SIGN REVIEW BOARD MEMORANDUM

- **SUBJECT:** SRB24-0011 Public hearing and consideration of a request from Hoar Construction for a variance to Chapter 106 (Signs) of the North Richland Hills Code of Ordinances at 8851 Boulevard 26, being 5.52 acres described as Lot 4R1, Block 2, Walker Branch Addition.
- **PRESENTER:** Clayton Comstock, Managing Director of Development Services

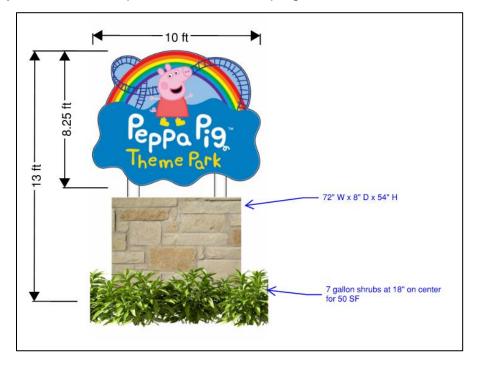
The applicant proposes to construct a pole sign adjacent to Boulevard 26. The proposed sign design is shown in the exhibit below. The proposed sign structure is 13 feet in height, with a sign message area of 82.5 square feet. The design of the sign includes a 4.5-foot tall masonry base with 50 square feet of landscaping around the base.
